IEEE P802.15
Wireless Personal Area Networks

Project	IEEE P802.15 Working Group for Wireless Personal Area Networks (WPANs)	
Title	MSCs Incorporating New FC SL/DME/MLME Functional Division and Imm-ACK Removal	
Date Submitted	[24 May, 2004]	
Source	[John Sarallo] [Apparent Technologies] [150 Lucius Gordon Drive, West Henrietta, NY 14586]	Voice: [585-727-2014] Fax: [585-214-2461] E-mail: [sarallo@apparent.com]
Re:	[]	
Abstract	[This document contains a list or proposed changes to IEEE Std 802.15.3.]	
Purpose	[The purpose of this document is to propose changes to IEEE Std 802.15.3 to improve compatibility, performance and clarity in the standard.]	
Notice	This document has been prepared to assist the IEEE P802.15. It is offered as a basis for discussion and is not binding on the contributing individual(s) or organization(s). The material in this document is subject to change in form and content after further study. The contributor(s) reserve(s) the right to add, amend or withdraw material contained herein.

This document presents new clause 8 MSCs resulting from Imm-ACKs no longer being used as confirmation commands as presented in 04/202r0 and with the following functional division

Figure 125 - MSC of a DEV synchronizing with a PNC

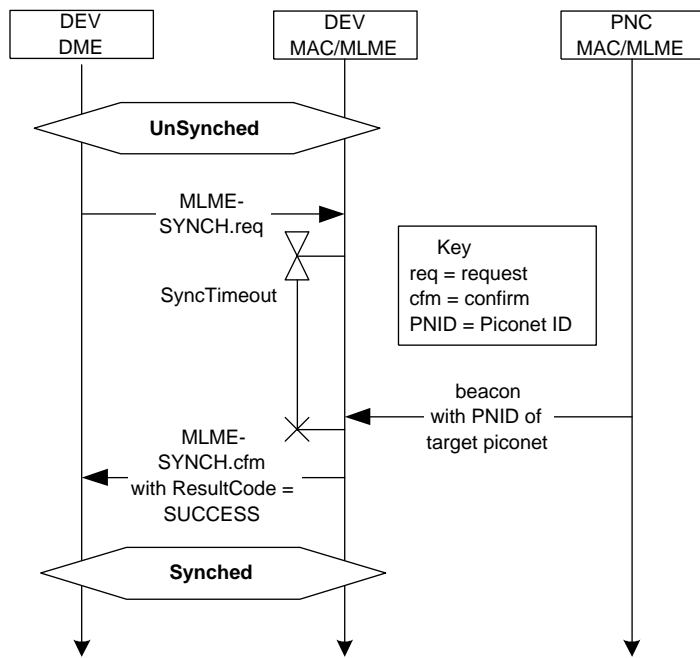
- DME can sync itself because it receives beacon indications. Therefore, MLME-SYNCH primitives are no longer needed.

Figure 102 - MSC of DEV-2 associating

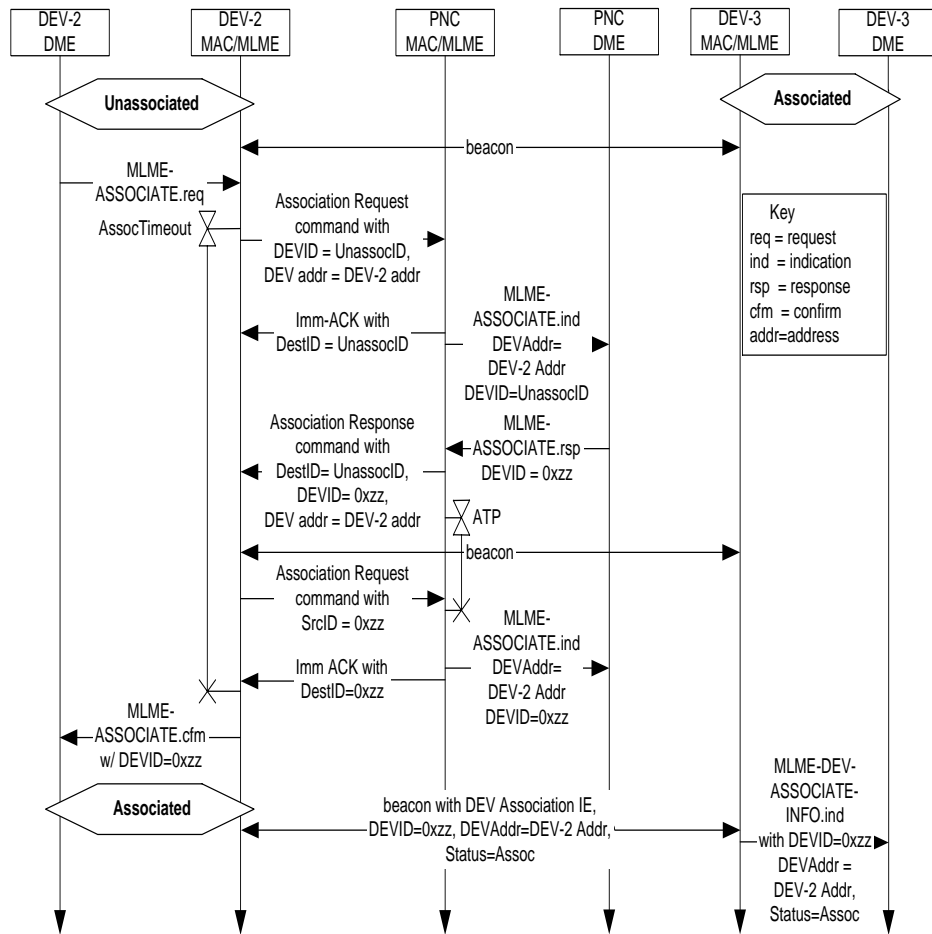
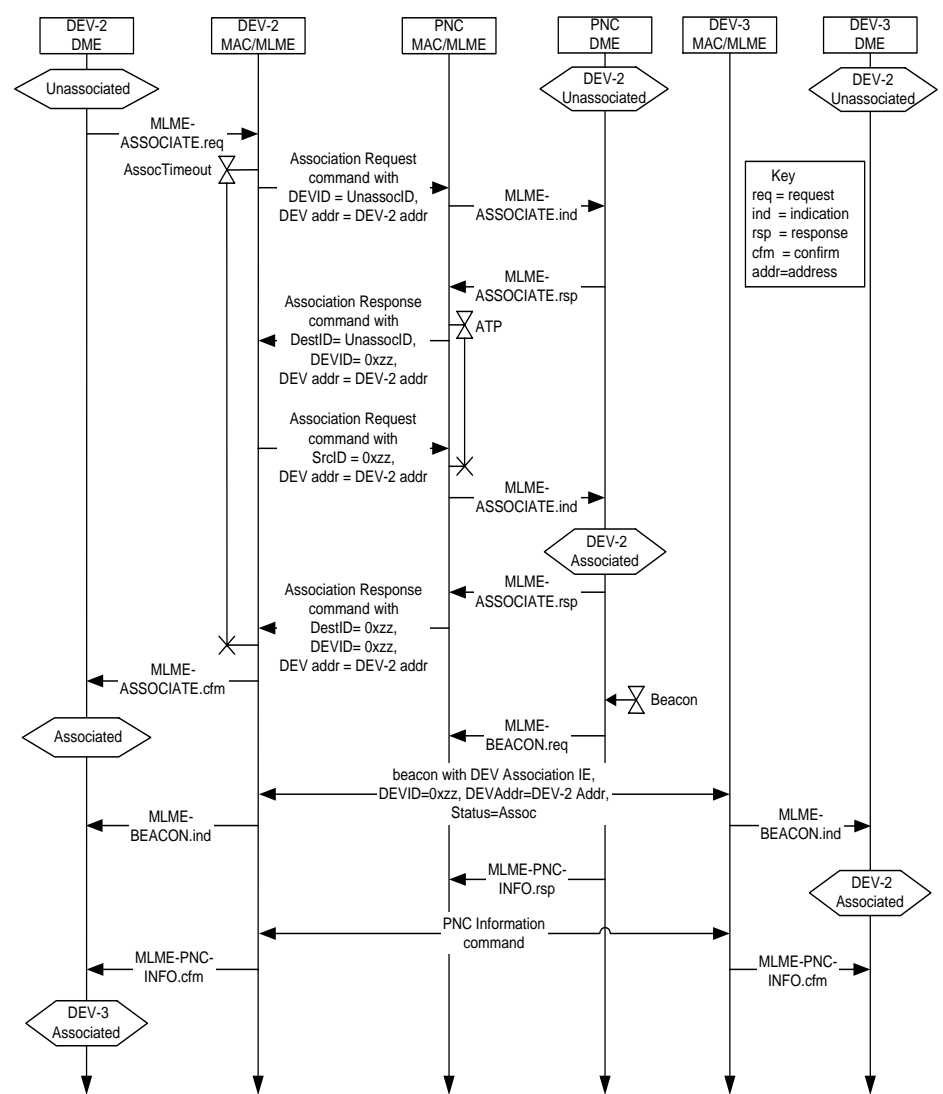
- Requesting DEV knows it is associated when it receives the second Association Response command. Other DEVs in the piconet know when they receive a beacon with a DEV Association IE. The associating DEV learns of other DEVs via the PNC Information command.

Figure 104 - DEV initiated disassociation MSC

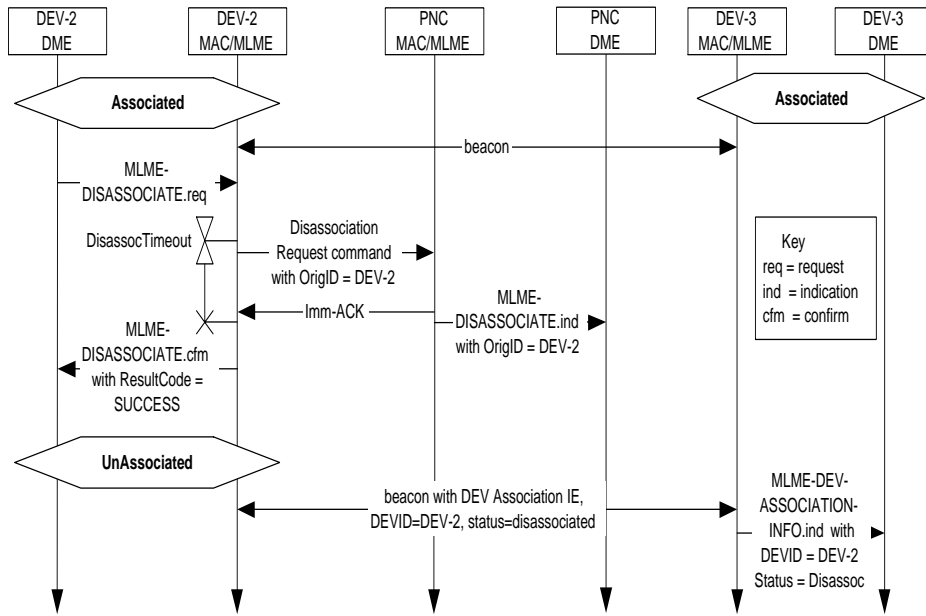
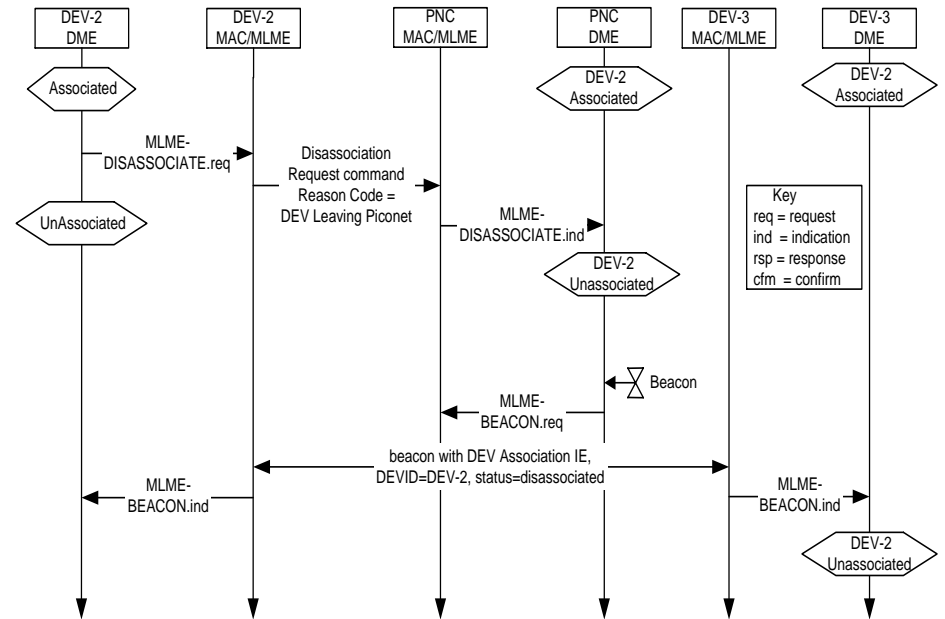
- DEV initiated disassociation is a “fire and forget” scenario.
- Disassociating DEV can immediately mark itself as disassociated. Other DEVs know when they receive a beacon with a DEV Association IE.

Figure 105 - PNC initiated disassociation MSC

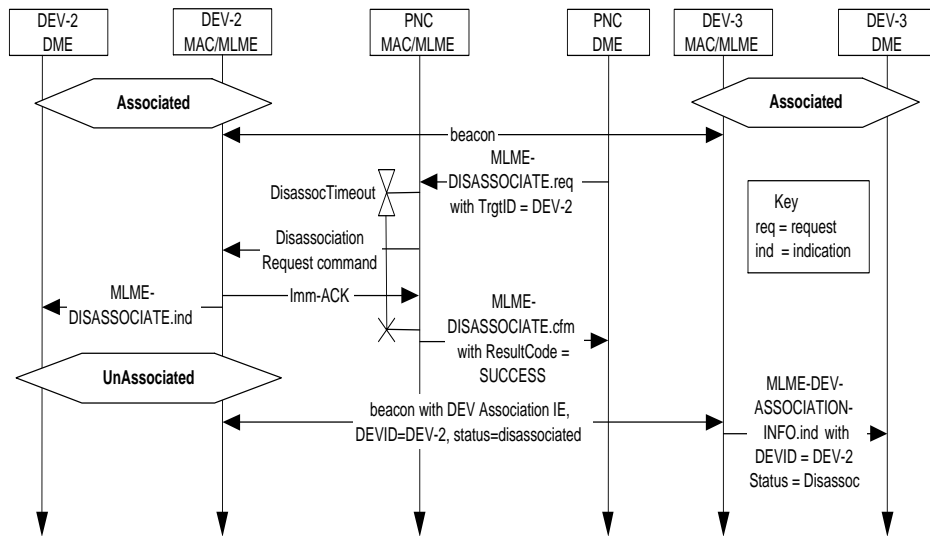
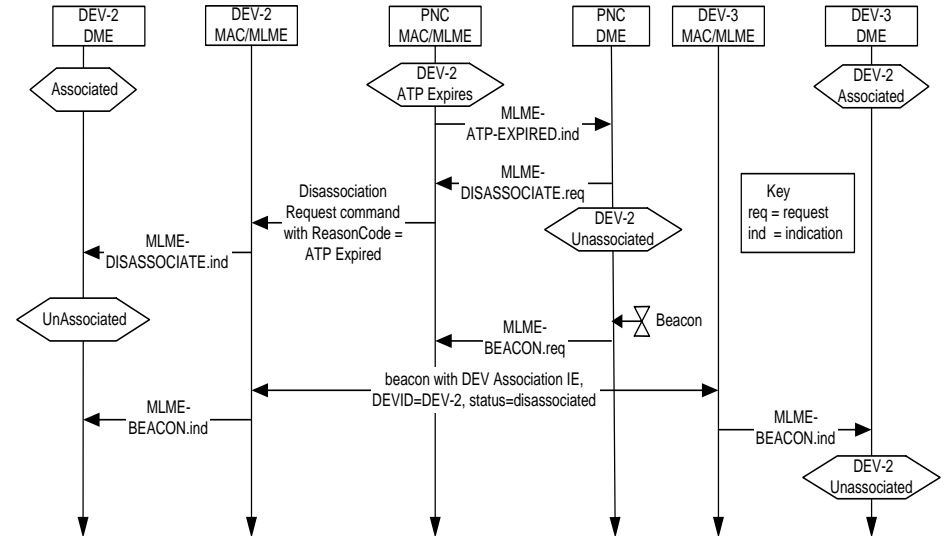
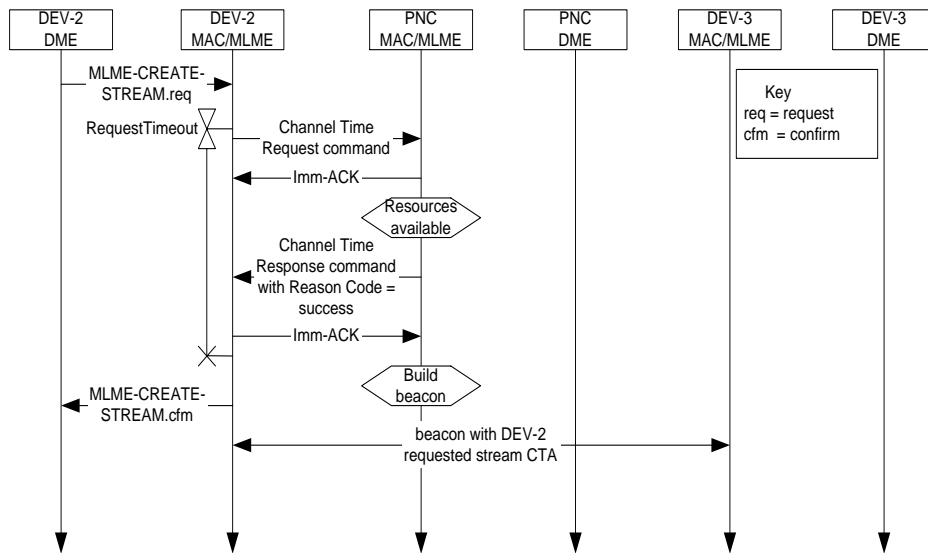
- PNC initiated disassociation is a “fire and forget” scenario.
- DEV is disassociated when it receives a MLME-DISASSOCIATE.ind. Other DEVs know about the disassociation when they receive a beacon with a DEV Association IE.
- If a DEV receives a beacon with a DEV Association IE indicating it is disassociated, it should consider itself disassociated.
- Took opportunity to add MLME-ATP-EXPIRED.ind to at least one MSC (Note: MAC/MLME must maintain ATP timers because the DME does not see data frames.)

Figure 114 - MSC for creating a DEV-2 to DEV-3 stream

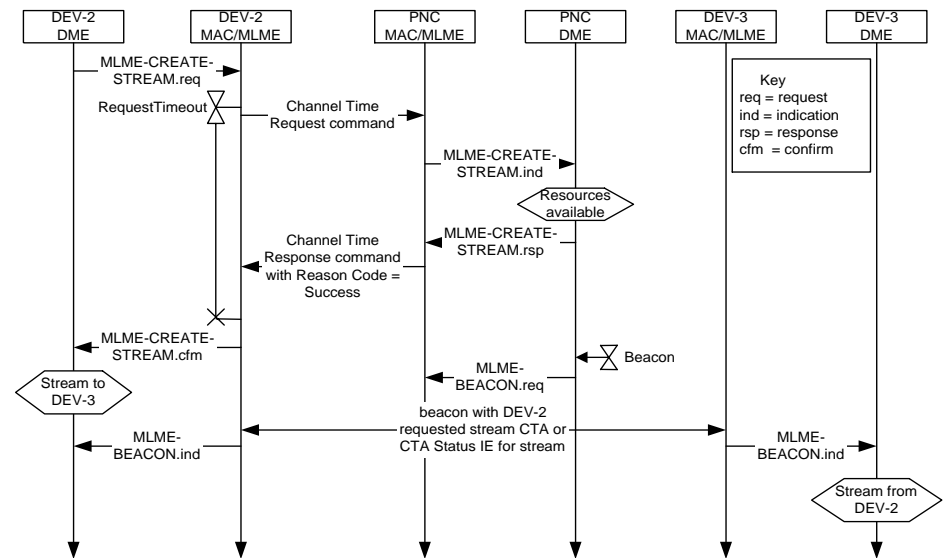
- PME is responsible for channel time allocation so MLME-CREATE-STREAM indication and response primitives are required.
- Requesting DEV knows stream is created when it receives the Channel Time Response command.
- Target DEV knows about the stream when it receives a beacon with a CTA or CTA Status IE indicating it is the target of a stream.

Figure 117 - MSC for modifying a stream

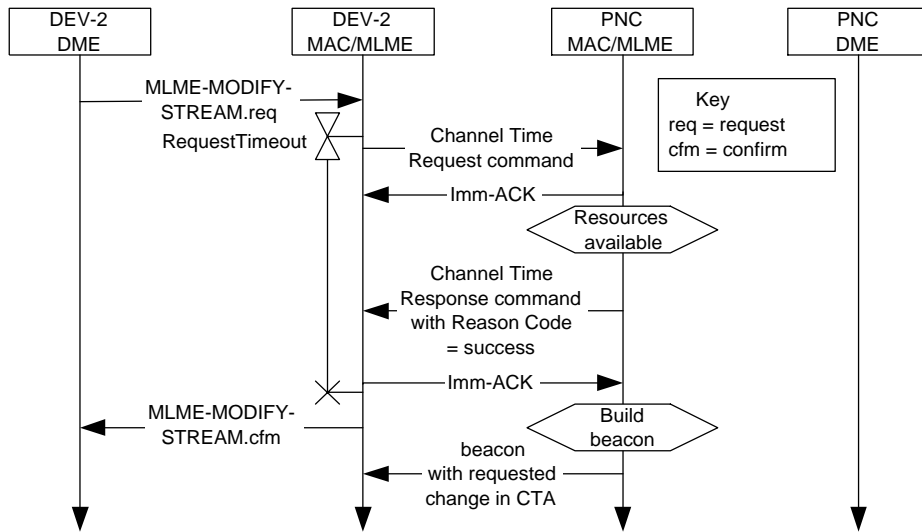
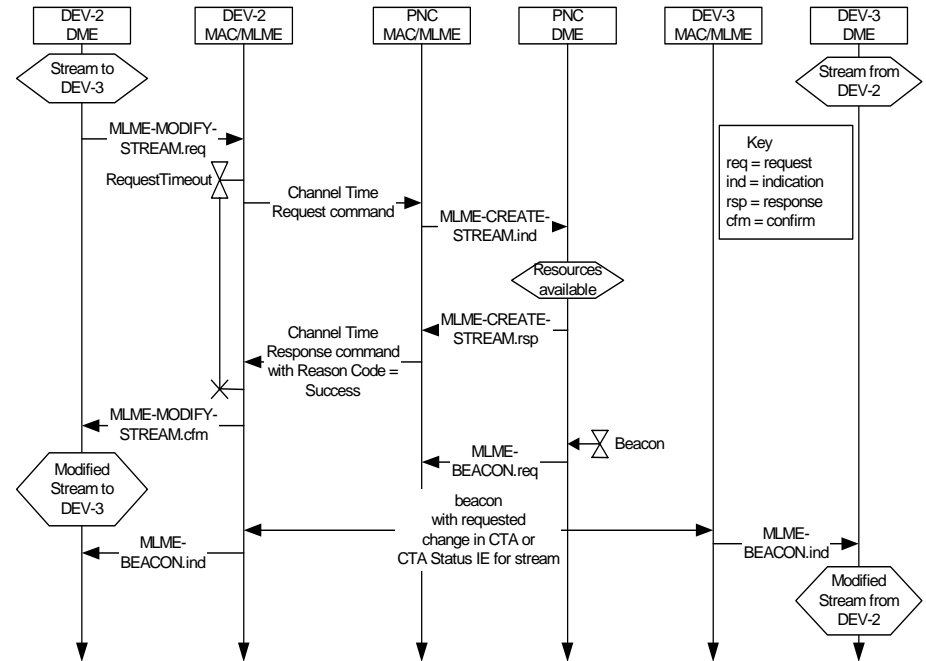
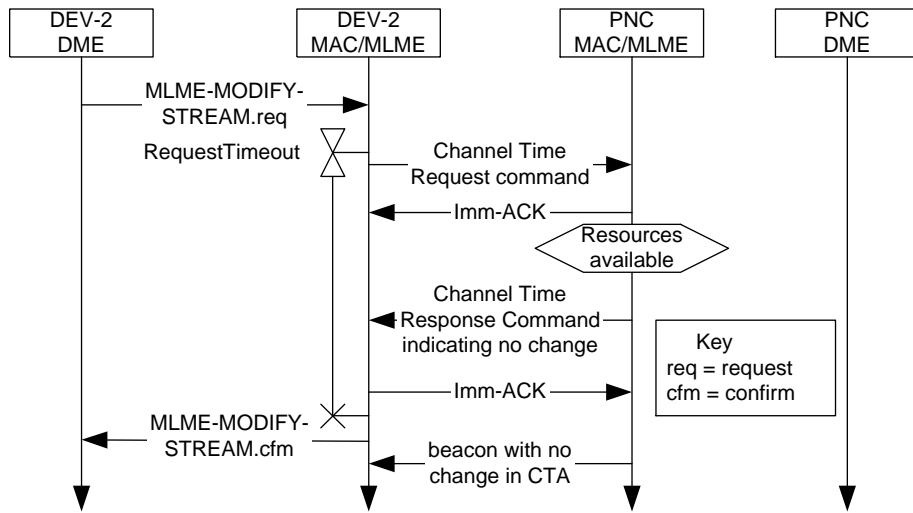
- Requesting DEV knows stream is modified when it receives the Channel Time Response command.
- Target DEV knows about the stream modification when it receives a beacon with a modified CTA or a CTA Status IE.

Figure 120 - MSC of source DEV-2 requesting termination of its stream

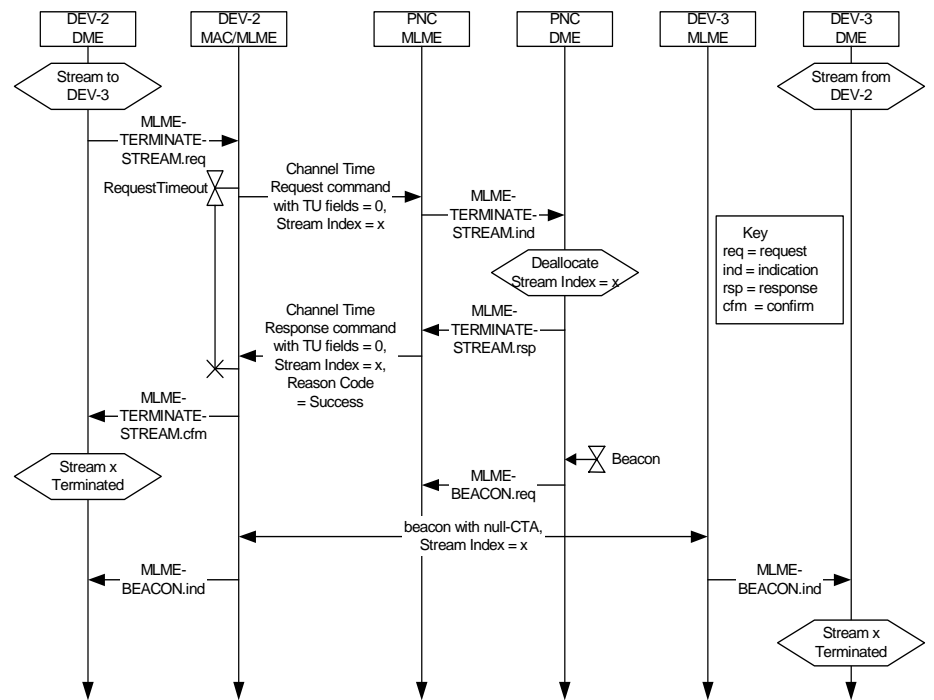
- If the we desire the target to know why a stream was terminated, then the target DEV must receive a Channel Time Response command. Otherwise, it will know the stream is terminated when it receives the Null CTA but it will not know why the stream was terminated.

Figure 121 - MSC of target DEV-3 requesting termination of source DEV-2's stream

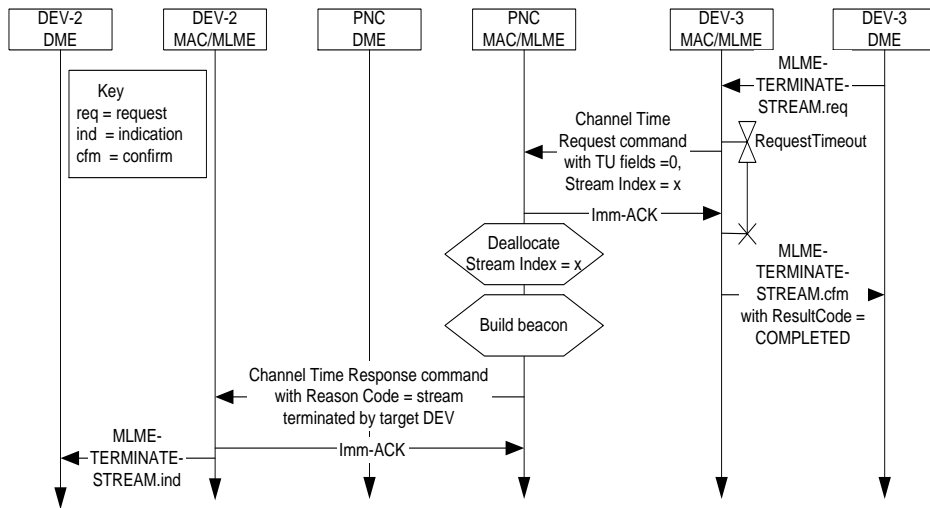
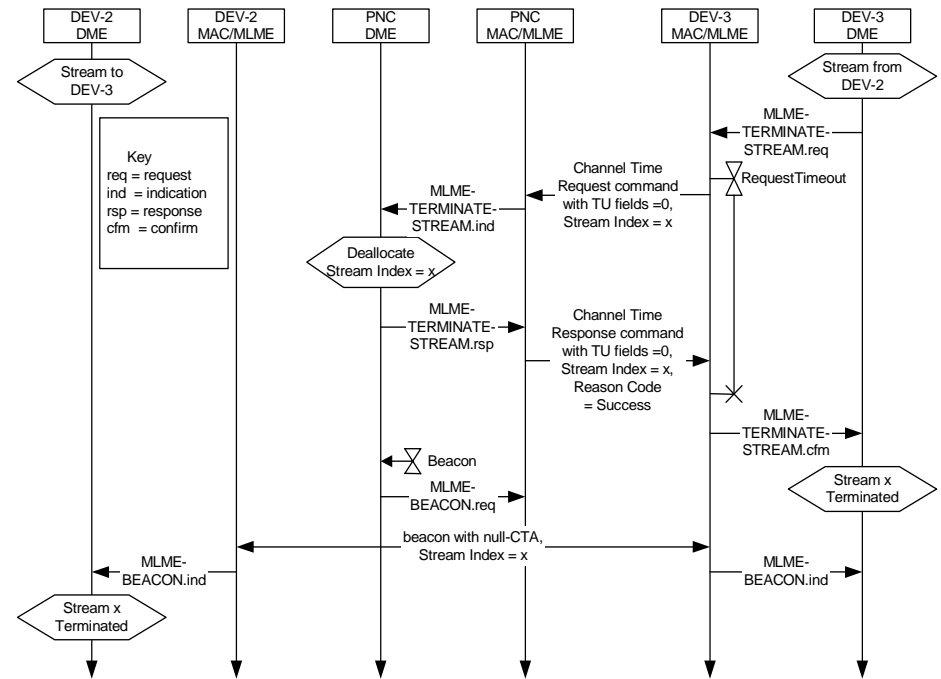
- If we desire the stream source to know why the stream was terminated, then the source DEV must receive a Channel Time Response command. Otherwise, it will know the stream is terminated when it receives the Null CTA but it will not know why the stream was terminated.

Figure 122 - MSC of PNC terminating a stream

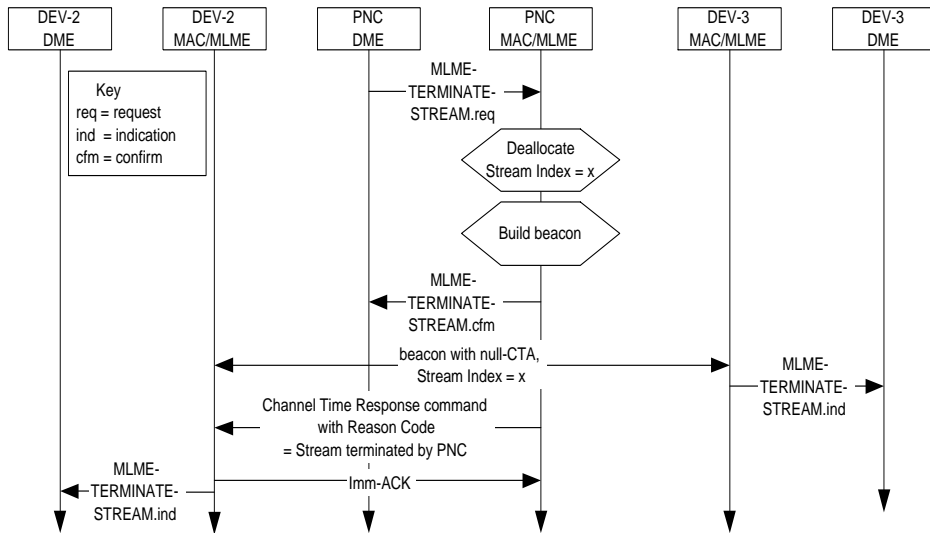
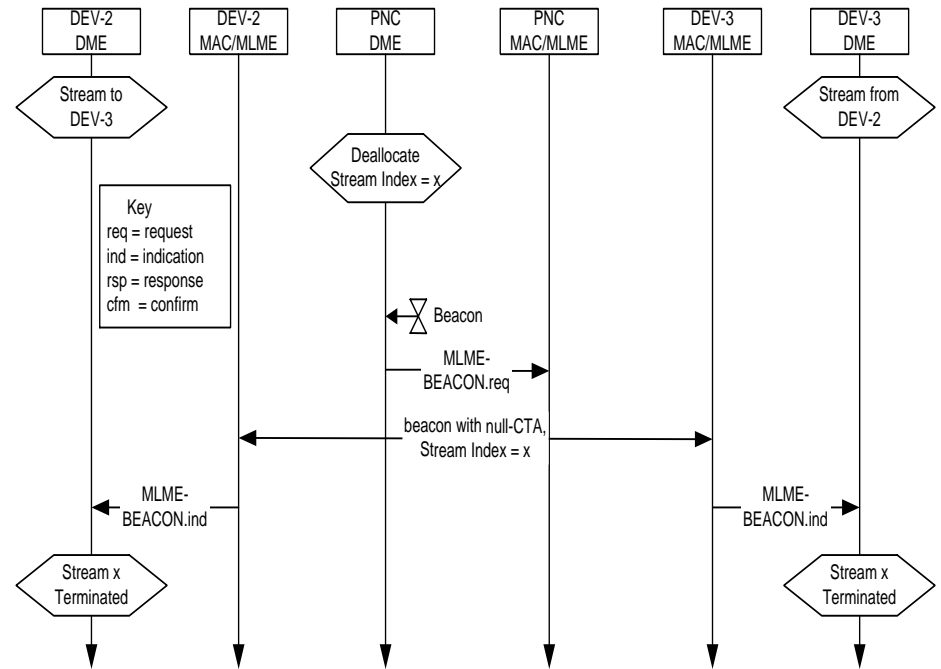
- If we desire the stream source and target to know why a stream was terminated, then both DEVs must receive a Channel Time Response command. Otherwise, both DEVs will know the stream is terminated when they receive the Null CTA but they will not know why the stream was terminated.
